SUBJECT: EDWIN I. HATCH NUCLEAR PLANT, UNITS 1 AND 2 - STAFF ASSESSMENT OF INFORMATION PROVIDED PURSUANT TO TITLE 10 OF THE *CODE OF FEDERAL REGULATIONS* PART 50, SECTION 50.54(f), SEISMIC HAZARD REEVALUATIONS RELATING TO RECOMMENDATION 2.1 OF THE NEAR-TERM TASK FORCE REVIEW OF INSIGHTS FROM THE FUKUSHIMA DAI-ICHI ACCIDENT (TAC NOS. MF3772 AND MF3773)

STAFF ASSESSMENT BY THE OFFICE OF NUCLEAR REACTOR REGULATION

RELATED TO SEISMIC HAZARD AND SCREENING REPORT

EDWIN I. HATCH NUCLEAR STATION, UNIT S. 1 AND 2

Figure 3.3-1 Plot of Staff's and Licensee's Base Case Shear-Wave Velocity Profiles for the Hatch site

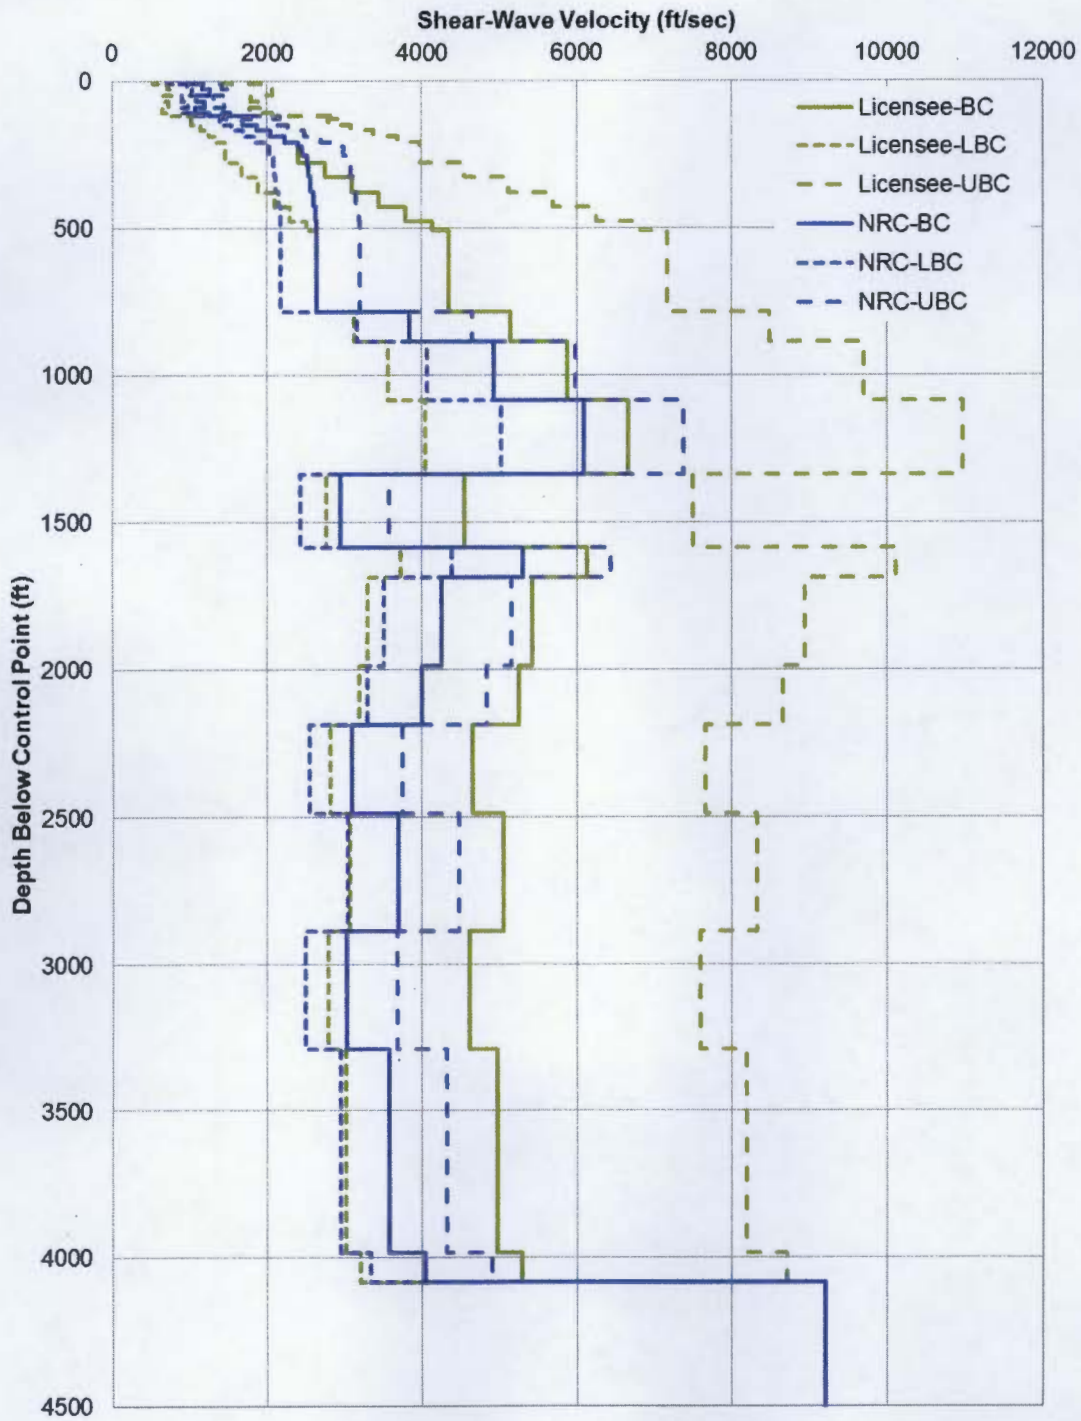
To characterize the subsurface geology, the licensee developed three site base case profiles. The middle, or best estimate, base case profile was developed using measured shear wave velocities from the ISFSI pad investigations for depths to 229 ft (70 m), linear interpolation was used for depths from 229 ft (70 m) to 509 ft (155 m), and nearby well data was used for portions of the profile deeper than 509 ft (155 m). To obtain the licensee's base case profile for depths greater than 509 ft (155 m), the licensee converted the well data from compressional wave velocities to shear wave velocities using a Poisson's ratio of 0.25. To account for uncertainty in

the profile, the licensee used a logarithmic standard deviation of 0.35 to develop the upper and lower base case profiles. Figure 3.3-1 of this assessment shows the licensee's three shear-wave velocity base case profiles.

To characterize the subsurface geology, the staff developed three site base case profiles. The middle, or best estimate, profile was developed using measured shear wave velocities from the ISFSI pad investigations for depths to 229 ft (70 m), the SPID template velocity profile for the layers between 229 ft (70 m) to 509 ft (155 m), and nearby well data for portions of the profile deeper than 509 ft (155 m). To obtain the its base case profile for depths great than 509 ft (155 m), the staff converted the well data from compressional wave velocities to shear wave velocities using relationships developed by Castagna (1985) and Brocher (2005). To account for uncertainty in the profile, the staff used a logarithmic standard deviation of 0.15 to develop the upper and lower base case profiles. Figure 3.3-1 of this assessment illustrates the velocity profiles the staff used in its confirmatory analysis.

subsurface as a weaker rock site with interbedded layers of soil. As such, the staff used a standard deviation of 0.15 to develop the upper and lower base case profiles. In contrast, the licensee used a standard deviation of 0.35, which is recommended by the SPID for sites with little or no subsurface data.

Figure 3.3-2 Plot Comparing the Staff's and the License's Median Amplification Functions and Uncertainties for two input loading levels for the Hatch site

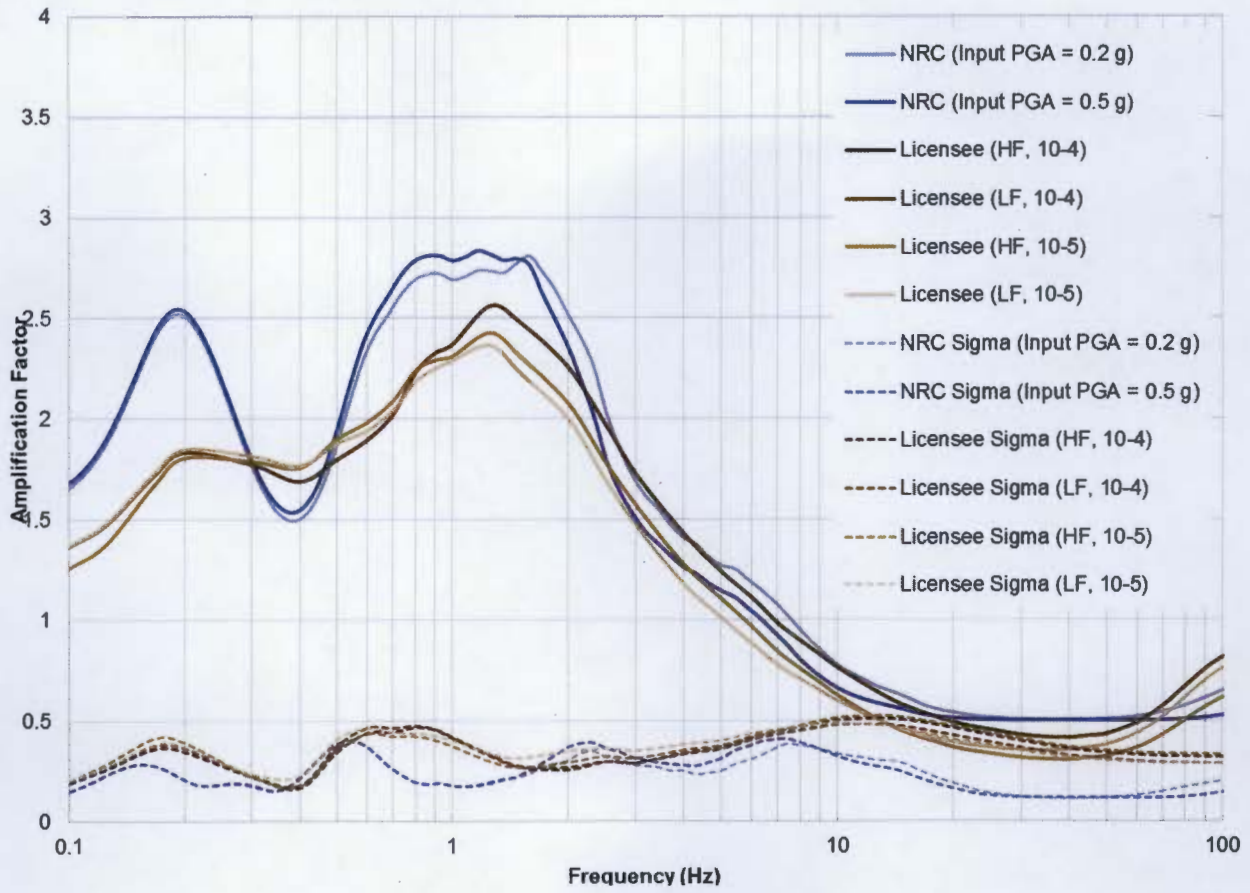
Figure 3.3-2 of this assessment shows a comparison of the staff's and licensee's median site amplification factors and uncertainties (± 1 standard deviation) for two of the eleven input loading levels. The staff's median site amplification factors are similar to the licensee's, except where the staff's amplification factors are larger than the licensee's values, at frequencies of approximately 0.2 Hz and between 0.5 to 2.5 Hz.

Overall, the licensee's approach to modeling the subsurface rock properties and their uncertainties results in site amplification factors that are similar in shape but somewhat lower than the staff's site amplification factors. This result is due to the wide range between the licensee's three base case velocity profiles, which extend from velocities around 2,500 ft/sec (762 m/sec) for the lower base case profile to over 10,000 ft/sec (3049 m/sec) for the upper base case profile. These shear wave velocity values are consistent with material in between soil and rock (lower base case) to a very stiff hard rock (upper base case). In contrast, the staff characterized the site

Figure 3.3-3 Plot Comparing the Staff's and the Licensee's Mean Control Point Hazard Curves at a Variety of Frequencies for the Hatch site

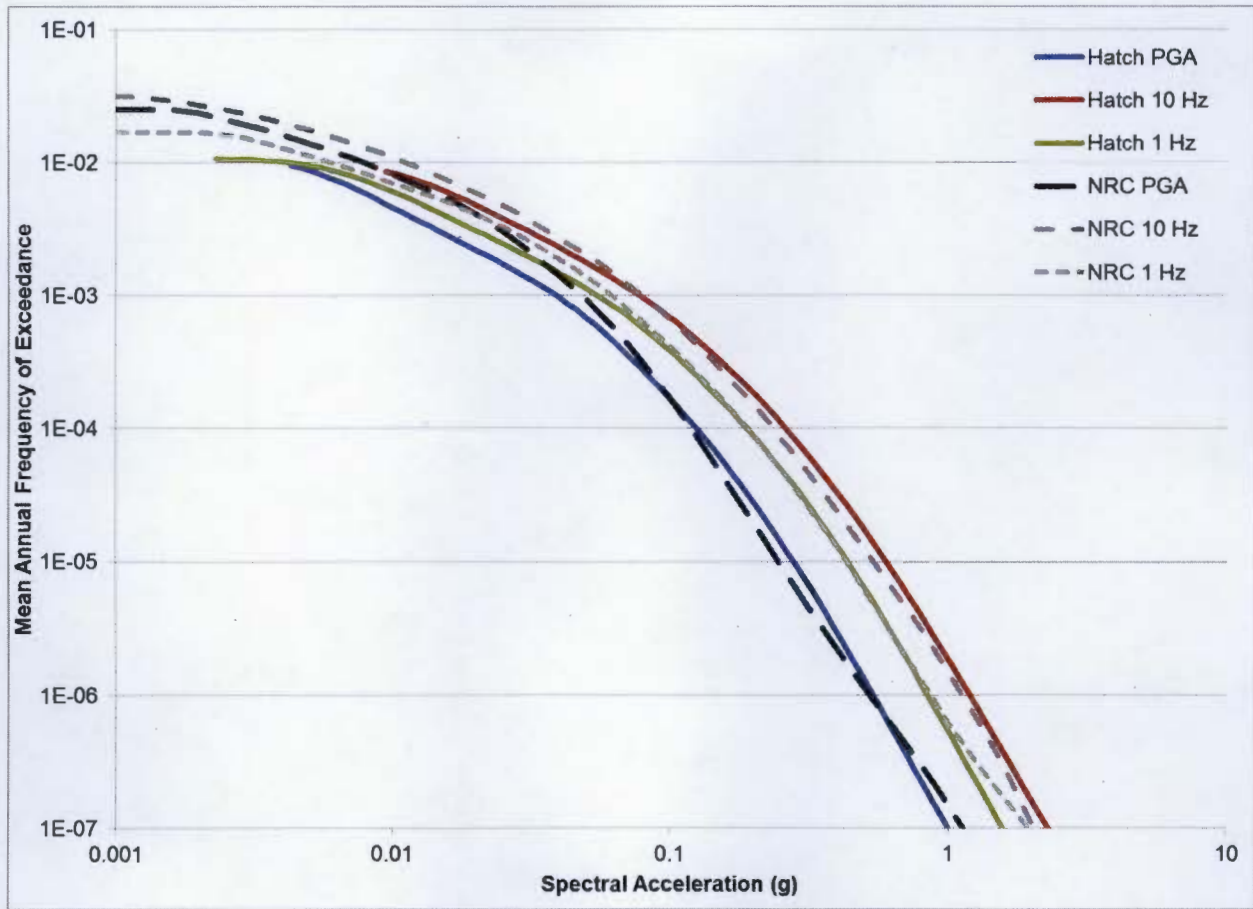
However, as shown in Figure 3.3-3 of this assessment, the differences between the licensee's and staff's site response analyses do not have a significant impact on the control point seismic hazard curves over the important annual frequency of exceedance range of 10^{-4} to 10^{-6} . Appendix B of the SPID provides guidance for performing site response analyses, including capturing the uncertainty for sites with less subsurface data; however, the guidance is neither entirely prescriptive nor comprehensive.

In summary, the staff concludes that the licensee's site response was conducted using present-day guidance and methodology, including the NRC-indorsed SPID. The staff performed independent calculations to confirm that the licensee's amplification factors and control point hazard curves adequately characterize the site response, including the uncertainty associated with the subsurface material properties, for the Hatch site.

Figure 3.4-1 Comparison of the Staff's GMRS with Licensee's GMRS and the SSE for Hatch Unit 1

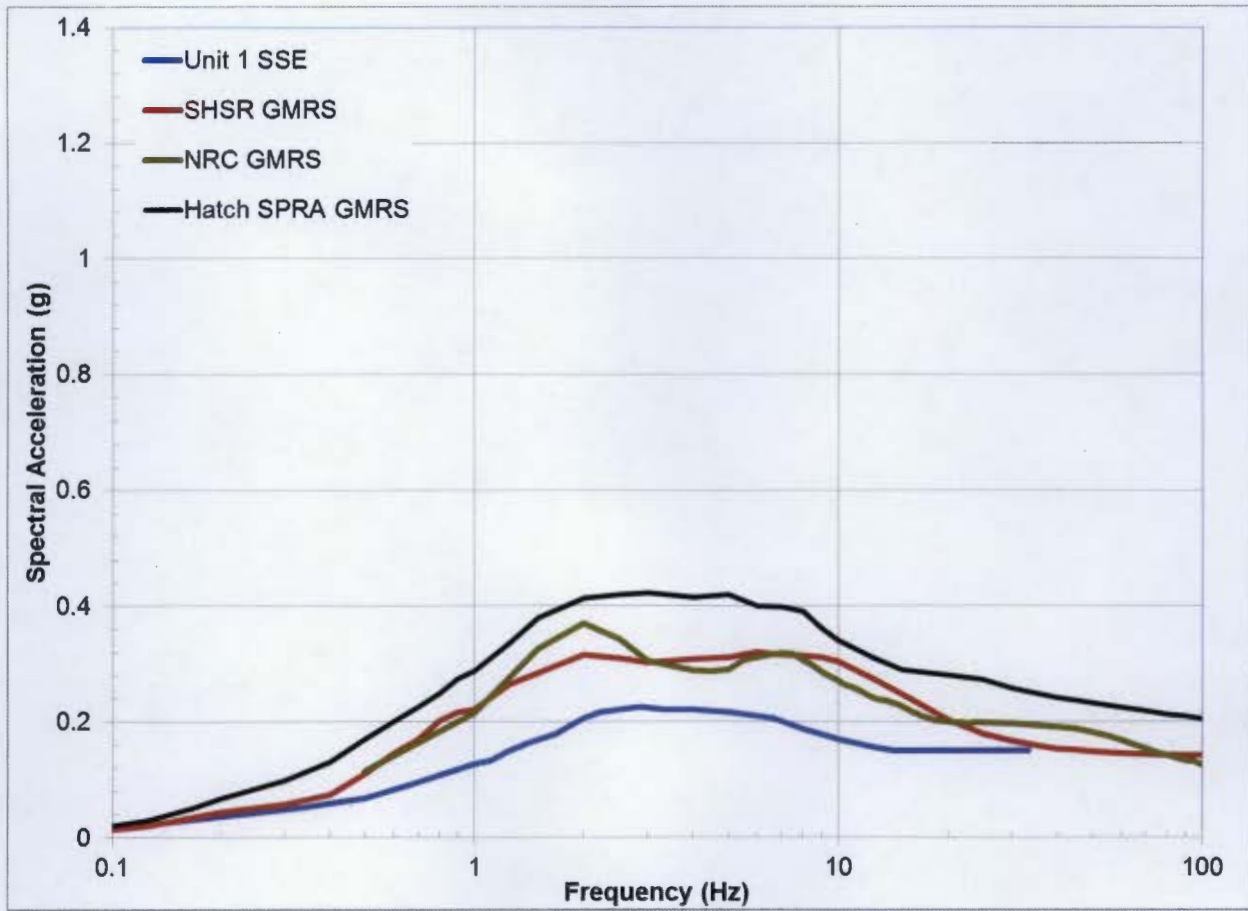
The staff independently calculated the 10^{-4} and 10^{-5} UHRS using the results of its confirmatory PSHA and site response analyses, as described in Sections 3.2 and 3.3 of this staff assessment, respectively. For Unit 1, Figure 3.4-1 of this assessment shows a comparison of the GMRS determined by the licensee (SHSR GMRS), the GMRS determined by the staff (NRC GMRS), and the Hatch, Unit 1 SSE. For Unit 2, Figure 3.4-2 of this assessment shows a comparison of the GMRS determined by the licensee (SHSR GMRS), the GMRS determined by the staff (NRC GMRS), and the Hatch, Unit 2 SSE.

As shown in Figures 3.4-1 of this assessment, the licensee's GMRS shape differs somewhat from that calculated by the staff, although both exceed the SSE for Hatch, Unit 1 at all frequencies. In addition, as shown in Figure 3.4-2 of this assessment, the licensee's and staff's confirmatory GMRS both exceed the SSE for Hatch, Unit 2 at most frequencies. The NRC staff's confirmatory GMRS is slightly higher than the licensee's at frequencies between approximately 1.5 to 3 Hz and above 10 Hz for both Hatch, Units 1 and 2. Also shown in Figures 3.4-1 and 3.4-2 of this assessment is the Hatch SPRA GMRS described in Pierce (2015). As described in Pierce (2015), the licensee will use the Hatch SPRA GMRS and associated hazard curves for its SPRA analysis, rather than the GMRS described in the SHSR. Because the Hatch SPRA GMRS is higher than both the licensee's SHSR GRMS and staff's confirmatory GMRS, the staff concludes that the Hatch SPRA GMRS and its accompanying hazard curves are acceptable for use in response to the 50.54(f) letter.

The staff confirms that the licensee used the present-day guidance and methodology outlined in RG 1.208 and the SPID to calculate the horizontal GMRS, as requested in the 50.54(f) letter. As such, the staff concludes that both the SHSR and SPRA GMRS determined by the licensee adequately characterize the reevaluated hazard for the Hatch site. In addition, since the licensee's SPRA GMRS envelopes both the licensee's SHSR GMRS and the staff's confirmatory GMRS, it is suitable for use in subsequent evaluations and confirmations, as needed, for the response to the 50.54(f) letter, dated March 12, 2012. The staff performed both a PSHA and site response confirmatory analysis and achieved results consistent with the licensee's horizontal GMRS.
